South Texas Project Electric Generating Station P.O. Box 289 Wadsworth, Texas 77483

September 16, 2009  
U7-C-STP-NRC-090134

South Texas Project  
Units 3 and 4  
Docket Nos. 52-012 and 52-013  
Responses to Requests for Additional Information

Attached are responses to NRC staff questions in Request for Additional Information (RAI) letter number 185, related to COLA Part 2, Tier 2, Sections 2.4S.5, "Probable Maximum Surge and Seiche Flooding," 2.4S.6, "Probable Maximum Tsunami Hazards," and 2.4S.13, "Accidental Releases of Radioactive Liquid Effluents in Ground and Surface Waters."

Figure 2.4S.5-XX. USGS Quadrangle showing Little Robbins Slough and Colorado River relative to the STP 3 & 4 Main Cooling Reservoir (MCR)

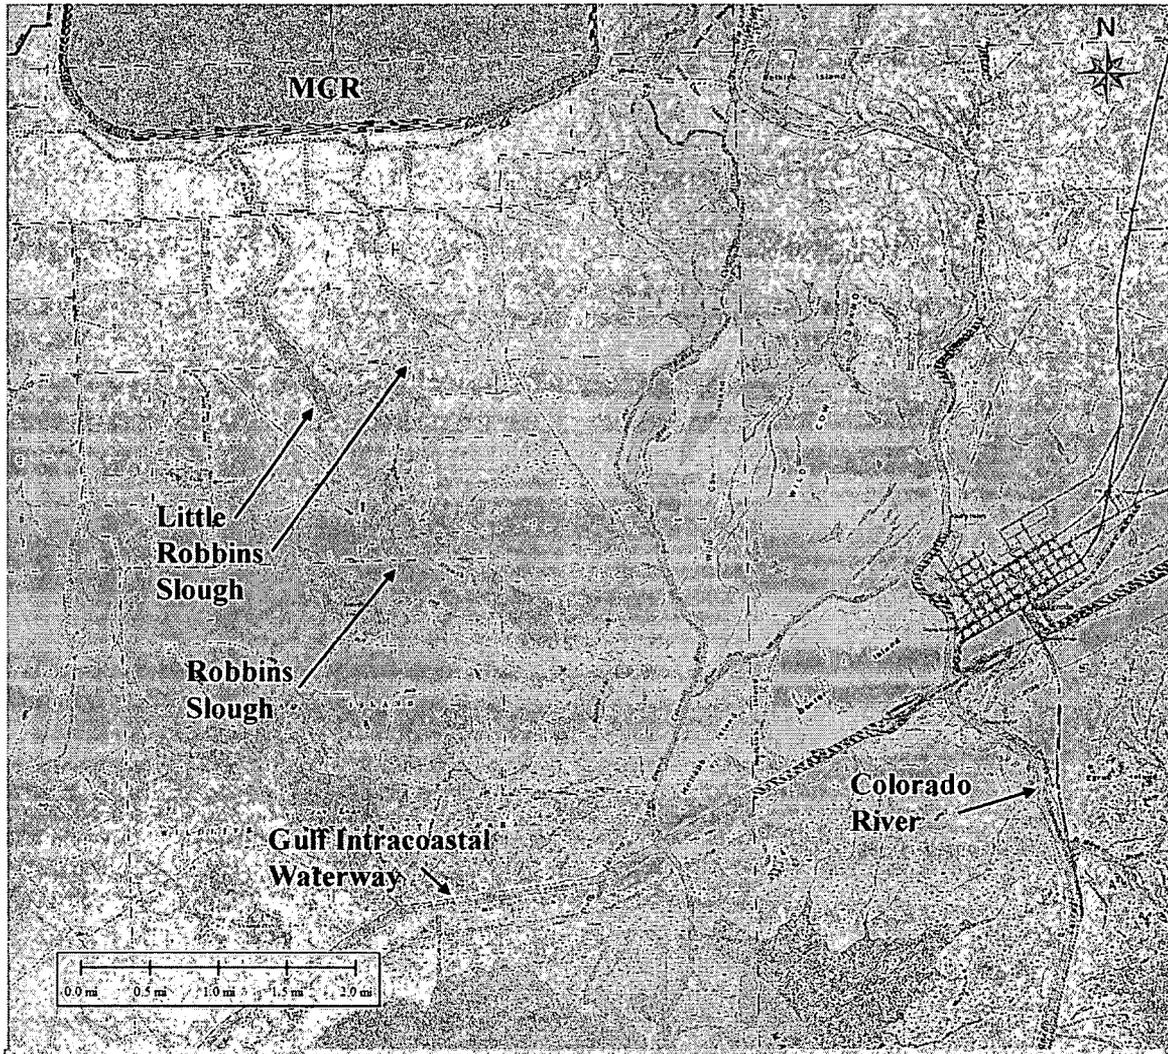
The applicant responded to RAI 02.04.05-3 in a letter dated August 27, 2008. The staff determined that the justification for not performing a PMH backwater calculation for the Little Robbins Slough should be included in the FSAR. Provide proposed text changes for FSAR Section 2.4.5 that address this issue.

The first paragraph of Subsection 2.4S.5.2.3.2 of STP COLA FSAR, Revision 3, which will be submitted in September, 2009, will be revised to include the justification provided in the response to RAI 02.04.05-3 for not performing a PMH backwater calculation for the Little Robbins Slough:

"A modified version of the Halff HEC-RAS hydraulic model (i.e., Reference 2.4S.5-10) was used to estimate the water surface elevation at STP 3 & 4 based on a backwater calculation on the Colorado River using the storm surge water surface elevation near the open coast as the downstream boundary condition. The Halff HEC-RAS model was developed for Halff's flood damage evaluation study and is discussed extensively in Subsection 2.4S.3. To be on the conservative side, however, the floodplain-extension used in HEC-RAS model of Subsection 2.4S.3 was not adopted in estimating the storm surge at STP 3 & 4. Little Robbins Slough near the STP site, shown in Figure 2.4S.5-XX, is a shallow multi-channel slough that joins Robbins Slough, a brackish marsh, which eventually drains to the Gulf Intracoastal Waterway. With the PMSS, it would be completely submerged and drowned out, thereby resulting in negligible water surface slopes for the backwater calculation. Therefore, the Colorado River is used for the PMSS backwater calculation in order to generate a bounding PMSS water level at STP 3 & 4."

**Figure 1. Submarine Mass Failure (SMF) regions in the Gulf of Mexico (Reference 3). Gulf of Mexico depth contours shown in meters below present-day sea level (Source: Reference 4).**

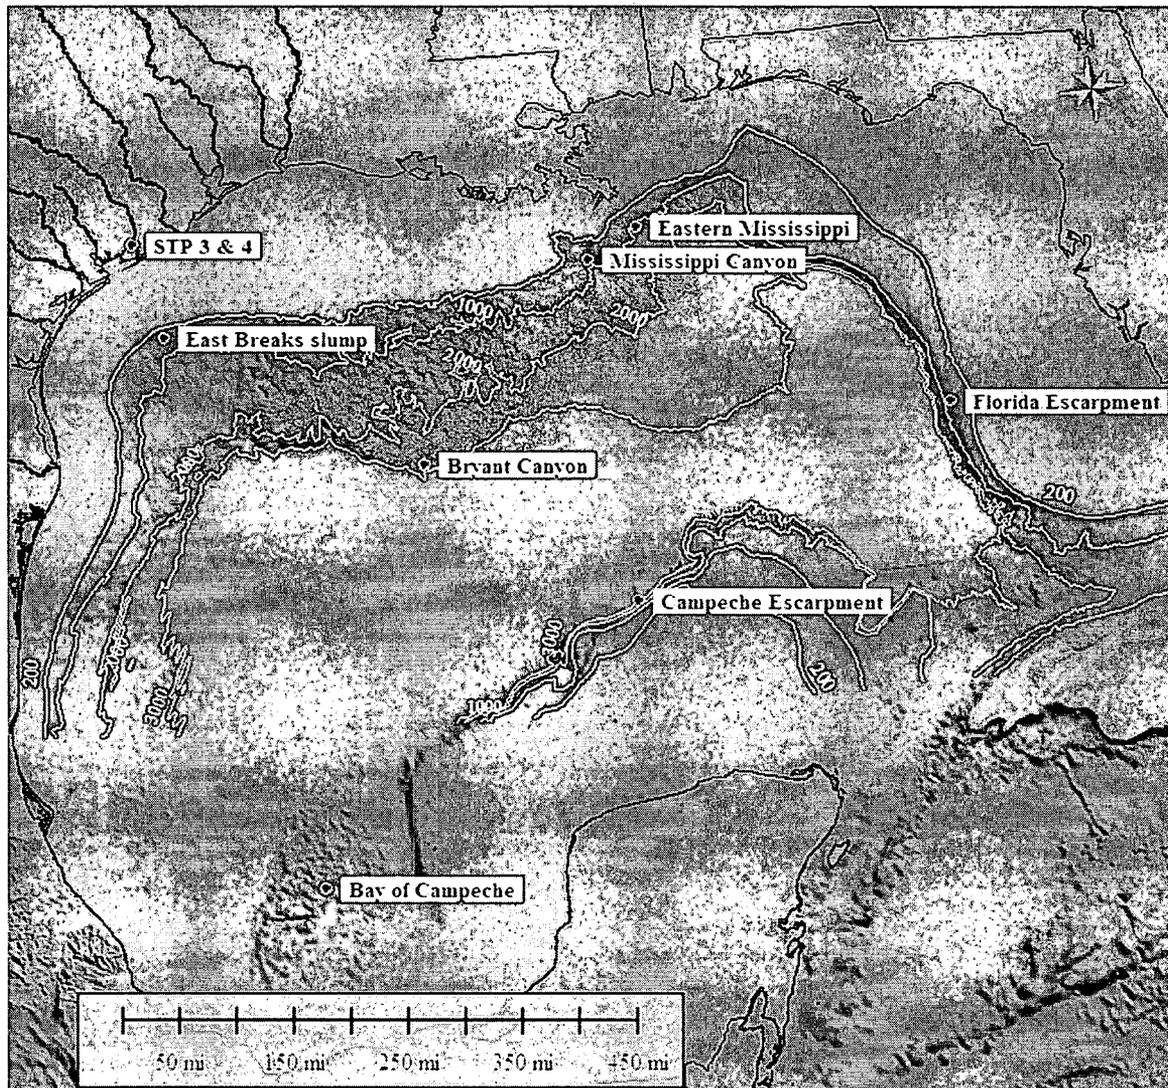
In the review by the staff of the response to RAI 02.04.06-1 (U7-C-STP-NRC-080067, December 4, 2008), the staff has generated the following additional questions: (1) It appears that the applicant's maximum tsunami water levels are not runup levels (including overland flow) but shoreline water surface elevations; (2) The applicant does not provide sufficient justification to dismiss the possibility that the Campeche Escarpment is a potential source for the PMT water levels; and (3) The applicant discusses the finding that no evidence of tsunami deposits was found near the site and that potential tsunami deposits from the East Breaks source would have been emplaced during sea-level low stand. However, they do not mention older tsunami deposits that occur during sea-level high stands, such as the Falls County tsunami deposit (Bourgeois and others, 1988). The applicant should clarify these issues and provide proposed text changes for FSAR Sections 2.4S.6.

With respect to Item (2), the Campeche Escarpment is located approximately 873 km (542 mi) from the STP 3 & 4 site. The Campeche Escarpment is much further away from the STP 3 & 4 site than the East Breaks slump, which is located about 142 km (88 mi) from the STP 3 & 4 site. Locations of the Campeche Escarpment and the East Breaks slump are shown in Figure 1 of this response. It is explained in the response to RAI 02.04.06-1 that tsunamis generated from submarine mass failures (SMFs) from remote areas of the Gulf of Mexico, such as the Campeche Escarpment, are not expected to exceed the four initial conditions simulated for the East Breaks slump. Maximum wave heights and minimum wave heights for the four simulated initial conditions are listed in Table 1.

Source parameters for the Campeche Escarpment postulated in Reference 3 do not exceed the source parameters that were simulated for the East Breaks slump in RAI 02.04.06-1. In addition, as tsunamis generated from landslides tend to be steep (i.e., high initial wave height relative to wavelength) and are prone to breaking, a tsunami event from a SMF in the Campeche Escarpment is not expected to propagate across the Gulf of Mexico and sustain wave heights that exceed the four simulated initial conditions for the East Breaks slump. As shown with the model simulations for the East Breaks slump, significant diffusion and energy dissipation of large initial waves occurs due to the continental shelf that extends offshore of the South Texas coast. Therefore, runup along the South Texas coast from a Campeche Escarpment event is likely to be negligible.
